FINAL MITIGATION PLAN

KEY MILL MITIGATION SITE

Surry County, NC
NCDEQ Contract No. 7180
DMS ID No. 100025

SUBJECT: Key Mill Mitigation Site - NCIRT Comments during 30-day Mitigation Plan Review

Project Site
	Proposed Conservation Easement
	Proposed Internal Crossings
Proposed Streams	
	Restoration
	Enhancement II
	Preservation
	Not for Credit
	Non Project Stream
	Reach Breaks
	Proposed BMP
	Easement Under 30' Buffer (3.3% of Total Site)

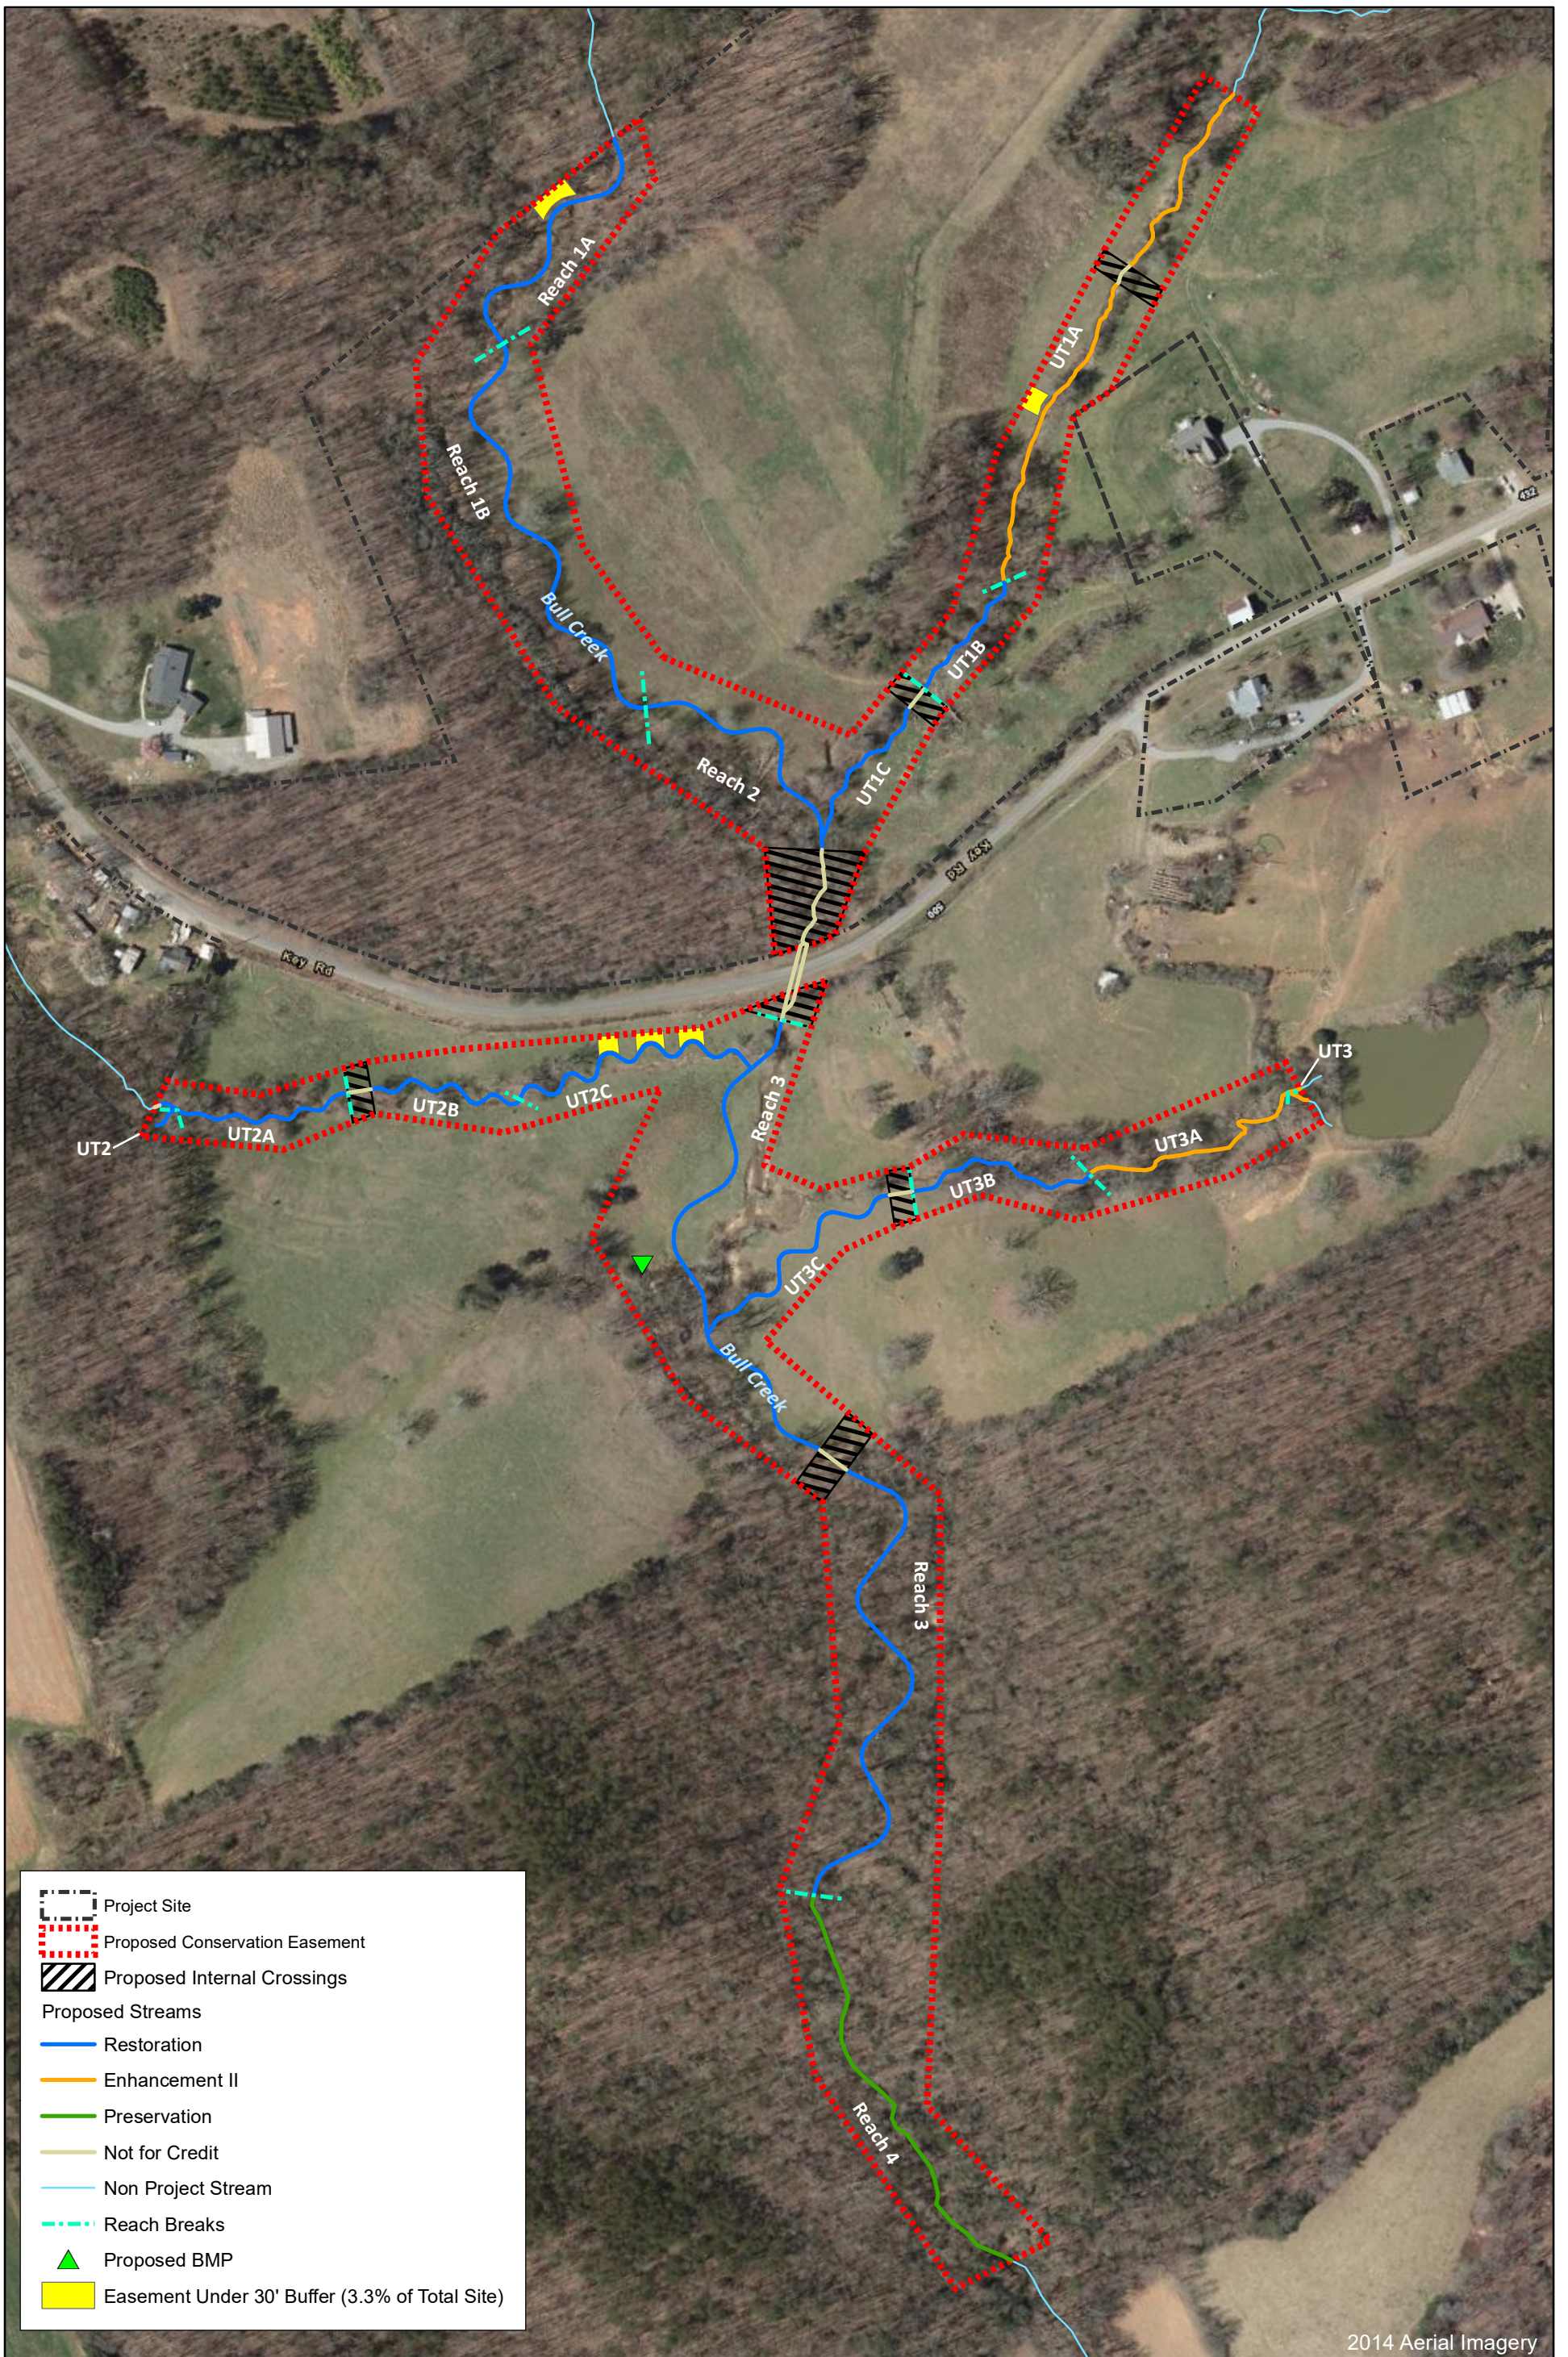
4. It's noted that there are three sections of channel where the minimum 30-foot buffer is not met. These areas should be clearly marked on the plan view.

A figure is enclosed that illustrates areas in which the proposed stream buffer is less than 30-feet wide. Based on the current design, less than 3.5% of the proposed stream mitigation length has a buffer less than required width. These areas are also shown on plan sheets 3.1 – 3.8.

Figure 6 Concept Design Map
Key Mill Mitigation Site
Yadkin River Basin 03040101

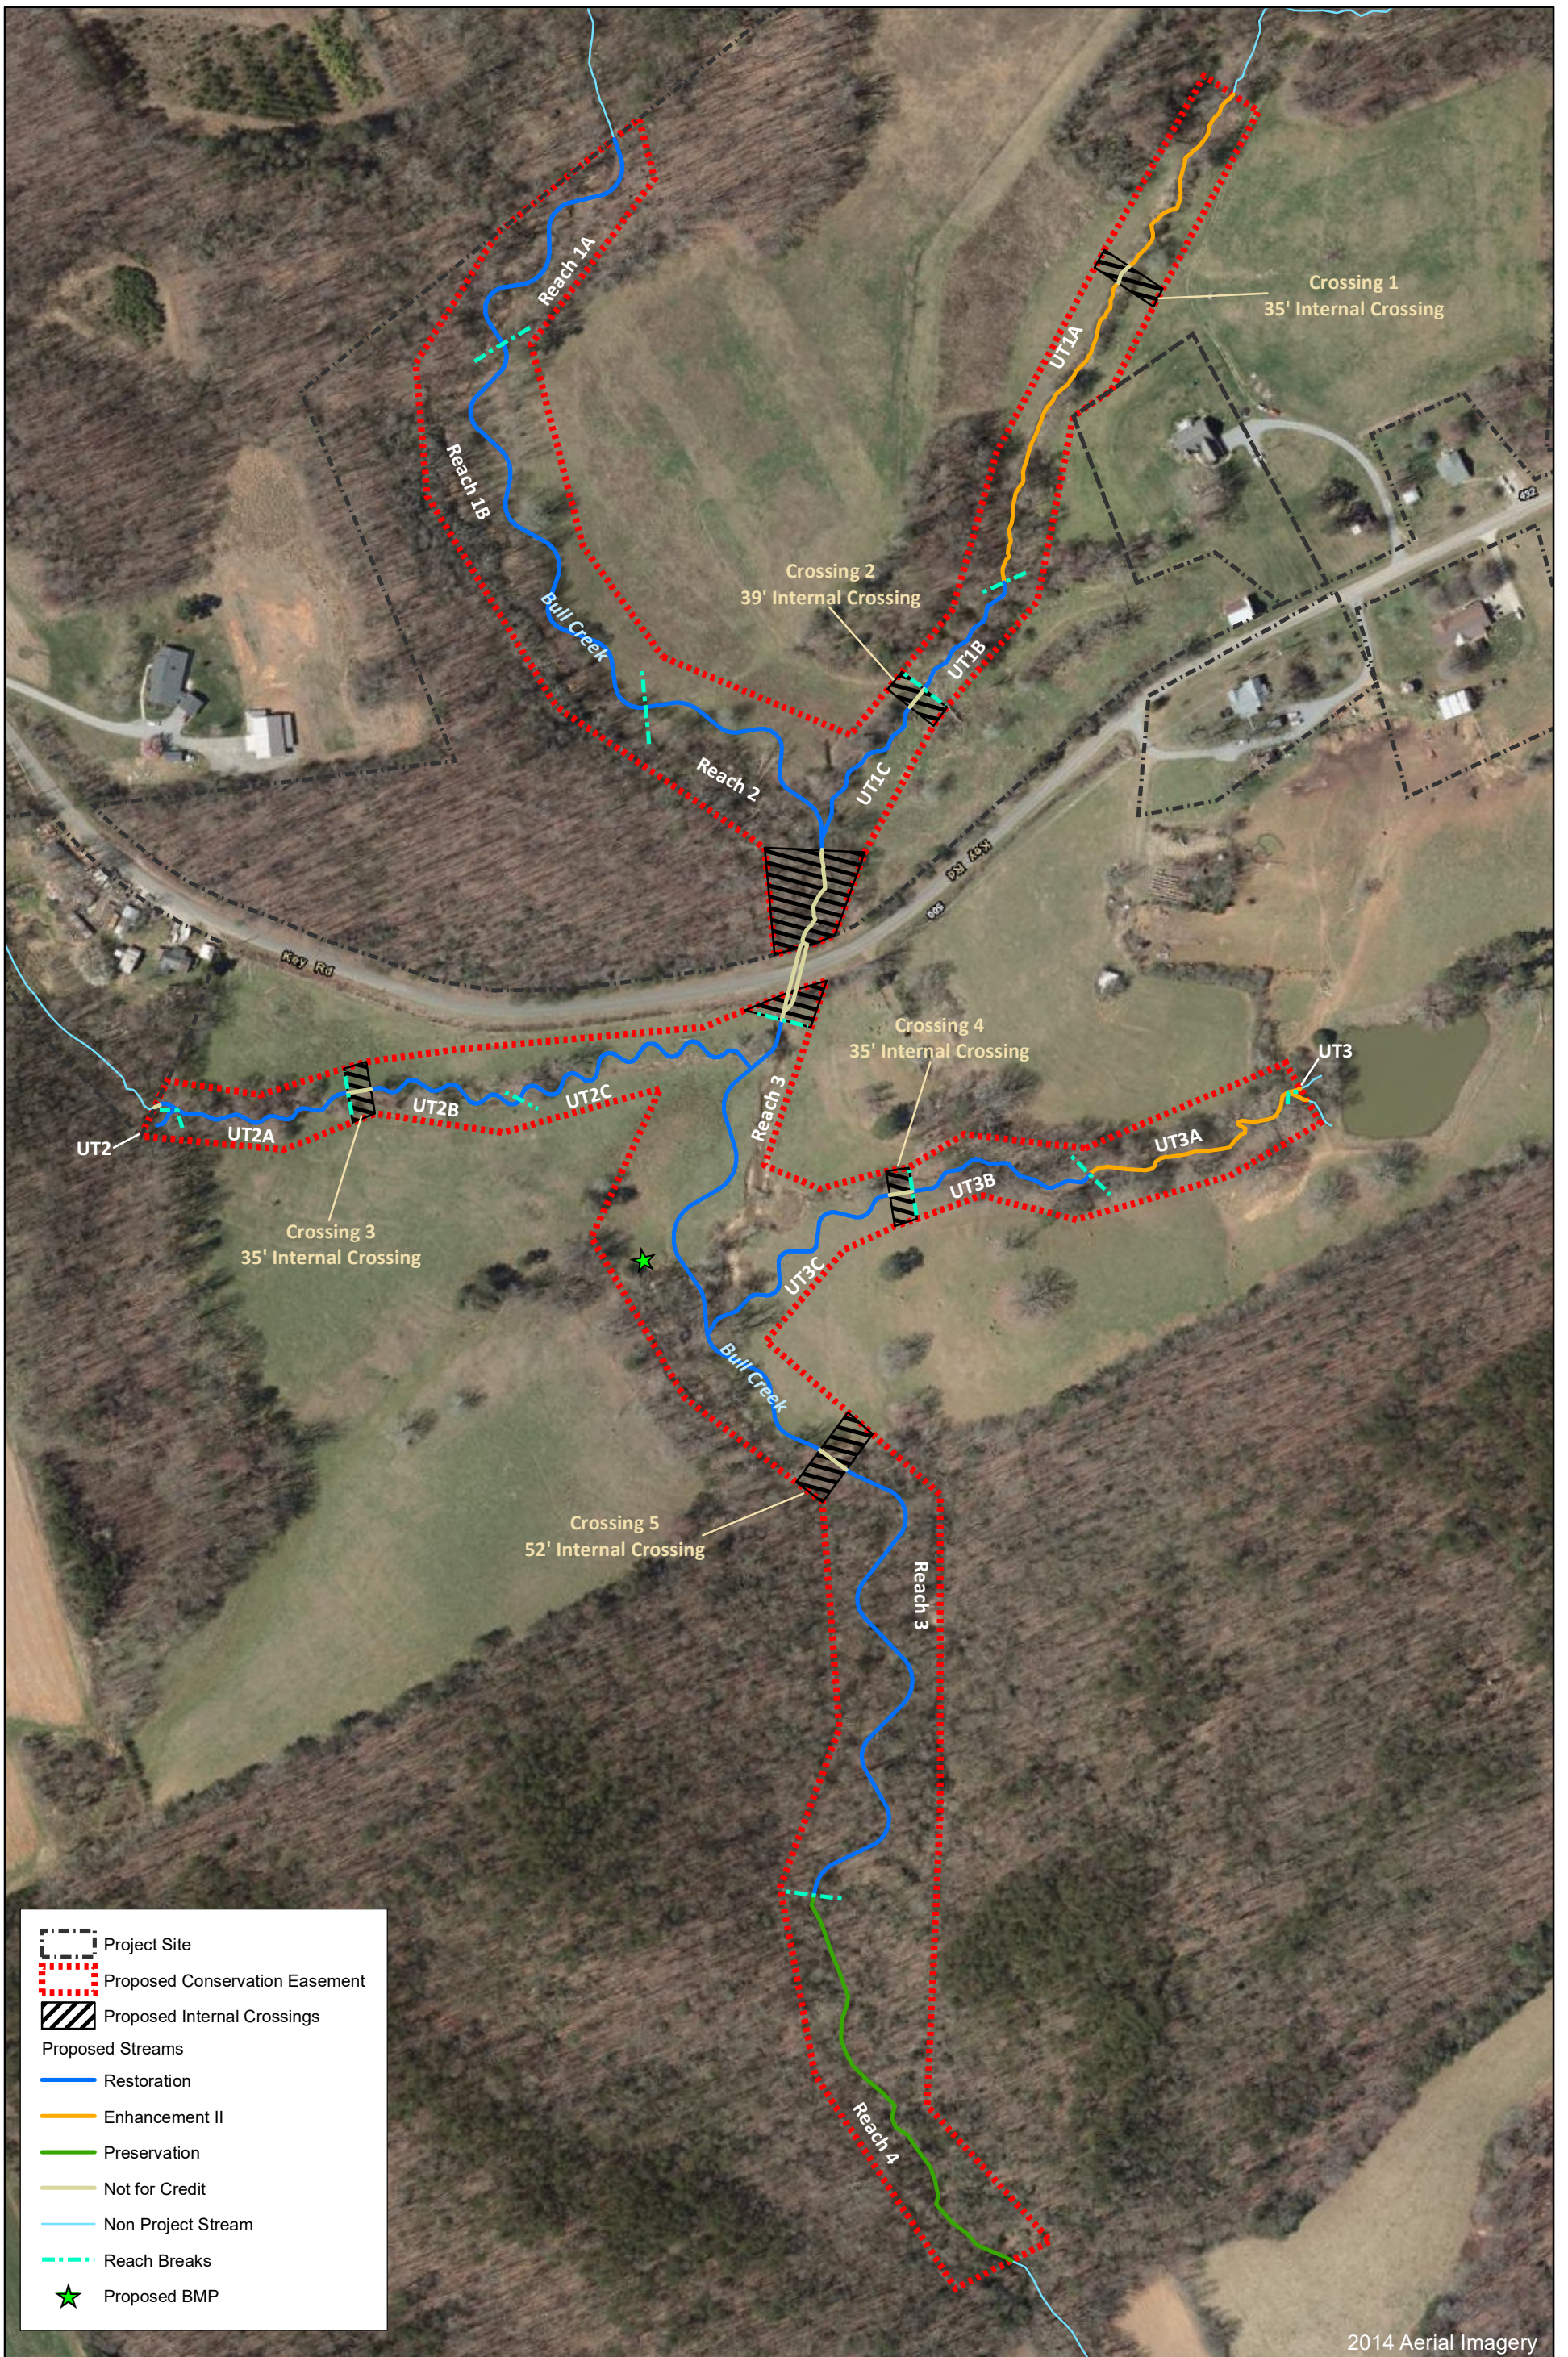
5. A stormwater BMP is mentioned in the narrative. Please provide a brief narrative of any maintenance required for the BMP, if any. Also, please label this area on the conceptual plan map.

Maintenance activities associated with the BMP are detailed in Appendix 8, as illustrated below. The location of the proposed BMP is illustrated on Figure 6.
